REQUEST

Proposed Zoning: MUDD(O) PED (mixed use development, optional, pedestrian overlay)

Approximately 1 acre located on the west side of the intersection of East Boulevard and Scott Avenue, east of Kenilworth Avenue.

STAFF RECOMMENDATION

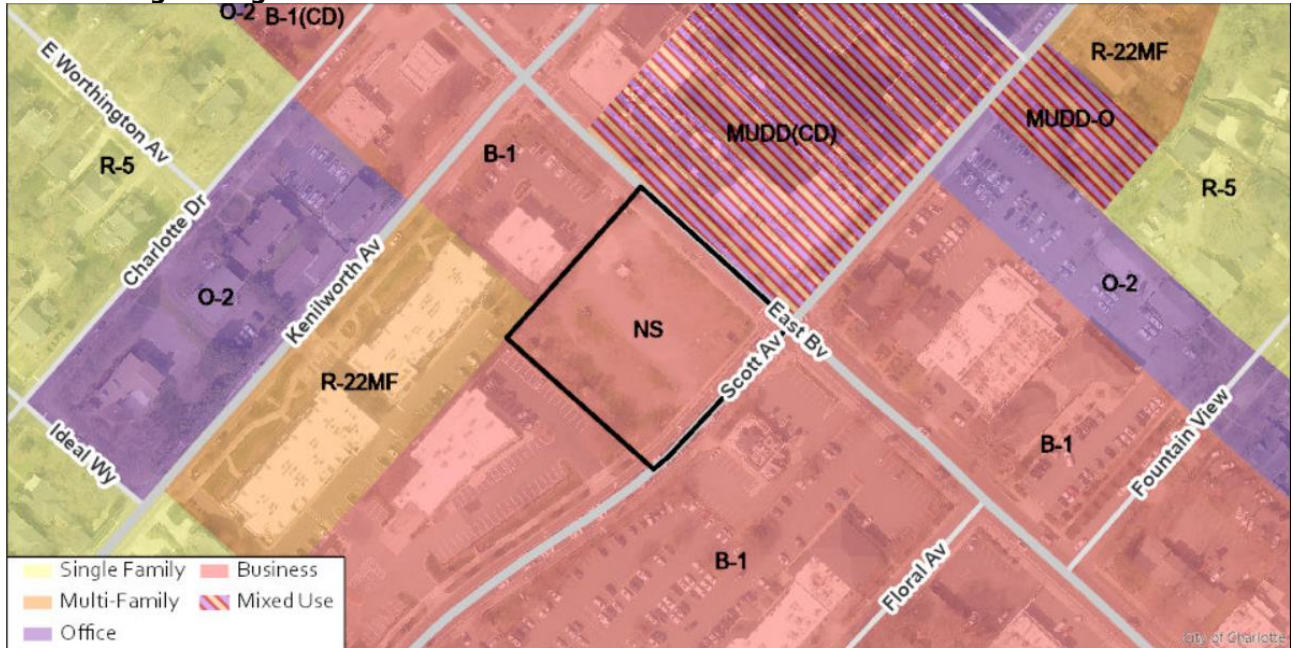
1. The proposed zoning district has a setback measured from back of the existing or proposed future curb. Scott Avenue: The future location of curb and gutter is in its existing location. East Boulevard: The proposed curbline and setback need to be revised from what is shown on the site plan.

2. The rezoning site is subject to the East Boulevard Pedscape Plan and cross section for East Boulevard between Kenilworth and Scott Avenues. Petitioner needs to meet the adopted streetscape or request an optional provision specifying deviations. Petitioner needs to clarify Transportation Note V.c.
3. Petitioner needs to clarify Transportation Note V.d., provide dimensions of the proposed sidewalk, planting strip, and other items agreed upon.
